Summary of Comments on Locus-Focus-Final-locations-4-28.pdf

Page: school22-overhead.jpg

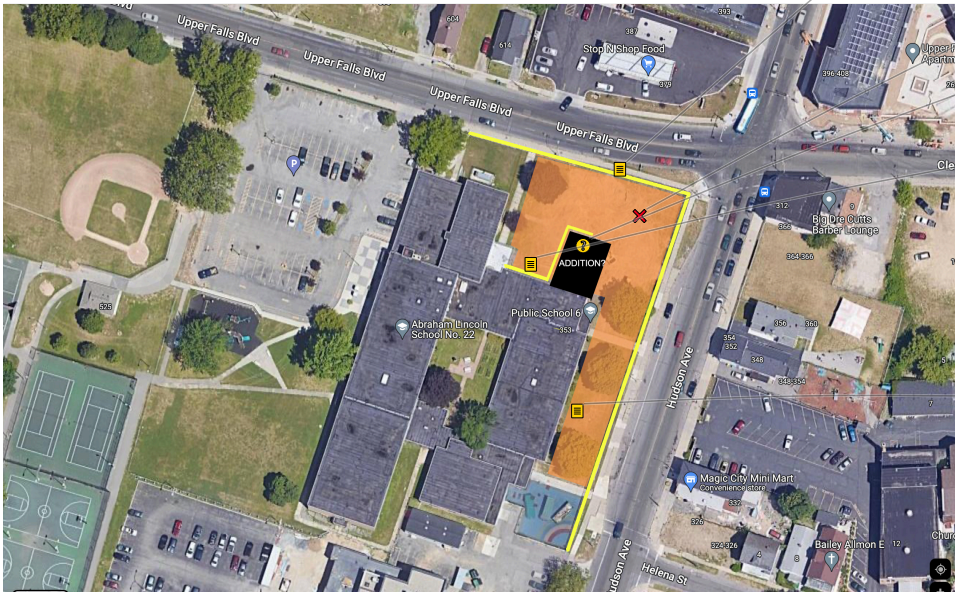
! PENDING CONFIRMATION FROM SCHOOL 22 ADMIN & FACILITIES: The fencing around the school on Upper Falls Blvd. and Hudson Ave. is not continuous. The fence is available for mounting upon approval by engineering that sections of sculpture created by panels of mosaic or mosaic sculpture that does not impede safe passage in the adjacent right of way.

Flag pole not included in available locations

AWAITING CONFIRMATION FROM SCHOOL 22 The overhead view from google maps appears to be prior to the construction of the Art Wing (?)

!! PENDING CONFIRMATION FROM SCHOOL 22 ADMIN & FACILITIES: The brick facade of the school indicated by the yellow line is available for mosaic installation (direct or mounted)

Please note that the areas closer to Upper Falls Blvd. are more desirable for mosaic application, as the intent of the program is to place artwork in areas that can be enjoyed by the community at large. For your design, please take into consideration what is most viewable from the sidewalk beyond the school grounds.

! PENDING CONFIRMATION FROM SCHOOL 22 ADMIN & FACILITIES: The grassy areas on either side of the front entrance to the school are available for sculpture placement.

NOT APPROVED

Page: school22-artwing-grounds.jpg

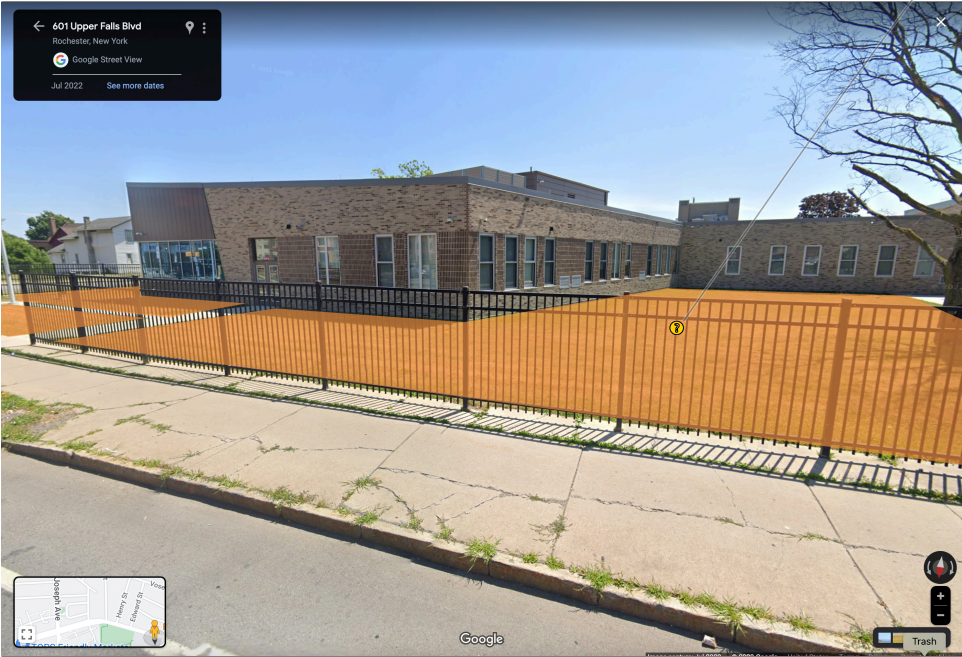
! PENDING CONFIRMATION FROM SCHOOL 22 ADMIN & FACILITES: The grassy area, indicated in orange, is available for sculptural installation.

Page: school22-artwing-facade.jpg

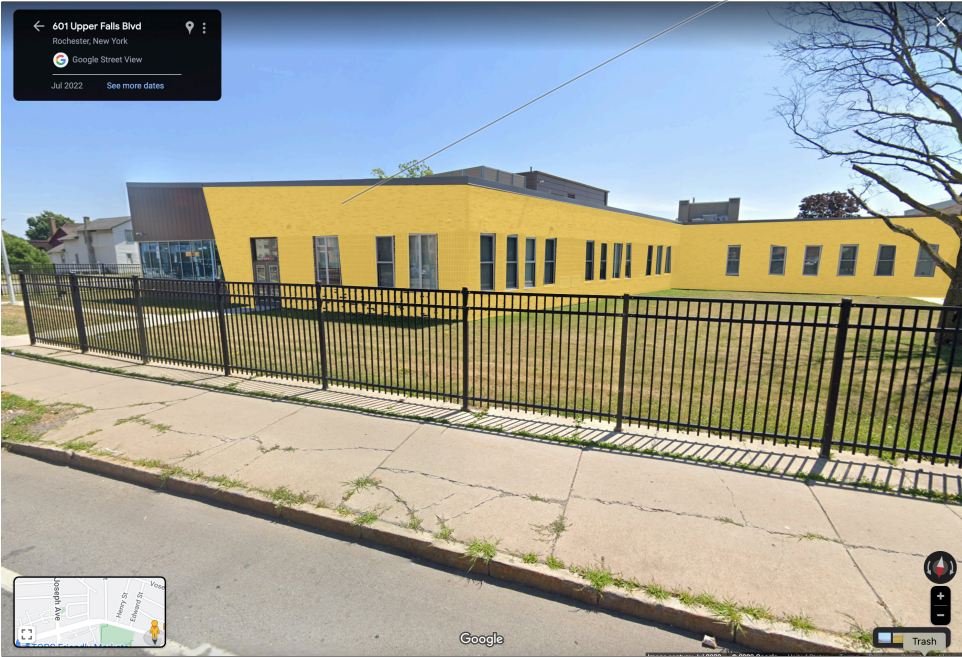
! PENDING CONFIRMATION FROM SCHOOL 22 ADMIN & FACILITIES: The brick facade of the school is available for mosaic installation (direct or mounted)

Please note that the facade closest to Upper Falls Blvd. is more easily seen from the sidewalk (this image is a google streetview which provides a slightly elevated view of the location)

This is a preferred location by the school administration. (Still waiting on Facilities review. Anticipated by 5/19 at the latest)

Page: school22-upperfalls-hudson-facade.jpg

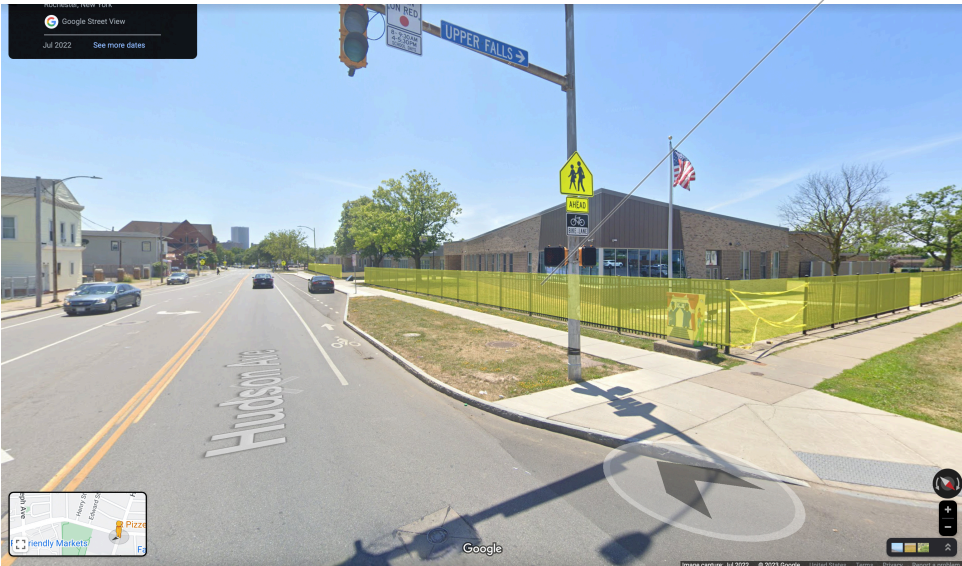
Author: Roc Arts United Subject: Site Notes Date: 4/28/23, 10:38:08 AM
! PENDING CONFIRMATION FROM SCHOOL 22 ADMIN & FACILITIES: The brick facade of the school is available for mosaic installation (direct or mounted)

Please note that the facade closest to Upper Falls Blvd. is more easily seen from the sidewalk (this image is a google streetview which provides a slightly elevated view of the location)
